Delegated Report

Householder Planning Application

Planning Application No: 20220677

Description: Creation of a vehicular access to driveway.

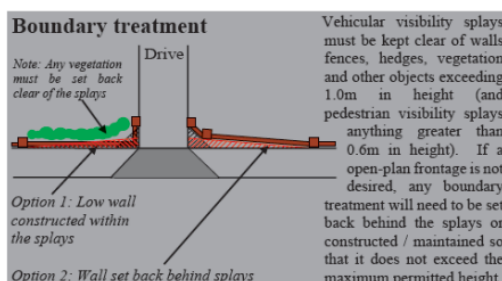
Generally, an application for a carriage crossover on an unclassified road would be dealt with directly by Kent County Council, but I note the planning reasons, which relate to the removal of the wall to permit access into the property.

In terms of the drive I note it will be formed with a permeable material which is appropriate, which means the application form is incorrect as drainage will be via a sustainable drainage system as it drains direct to ground and not an existing water course. No details are provided for the construction of the drive, but if permitted it should be from a bound material either an appropriate resin or blocks installed in accordance with the manufactures instructions.

As far as is possible within the applicants land ownership pedestrian visibility splays are required adjacent to the drive.

This would appear to require the lowering of the wall on the corner of Darnley Road and Trafalgar Road and also the lowering of some vegetation, which may or may not be acceptable.

This property already benefits from an access at the rear of the property, although I accept the situation would not meet current requirements it is there and the proposed access is less than 5 metres from the junction. On this basis, I cannot see Kent County Council approving another access from Darnley Road given the guidance repeated above and so the removal of the wall would be pointless. My recommendation is therefore one of refusal.

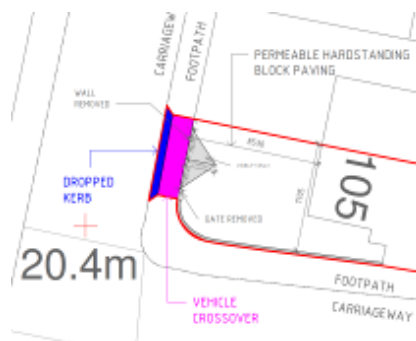
It is also worth noting that there is a garage with a vehicular access to the rear of the property which is accessible via Trafalgar Road and provide off road parking. No supporting information has been provided to explain why additional parking is required to the front of the property or why the current arrangement to the rear may or may not be suitable.

As mentioned previously there is space at the rear for vehicular parking. The screenshot below from Google Earth was from 2022 which shows access to what appears to be a garage which demonstrates that the site has some off street parking provision, avoiding the need for the loss of biodiversity currently proposed.
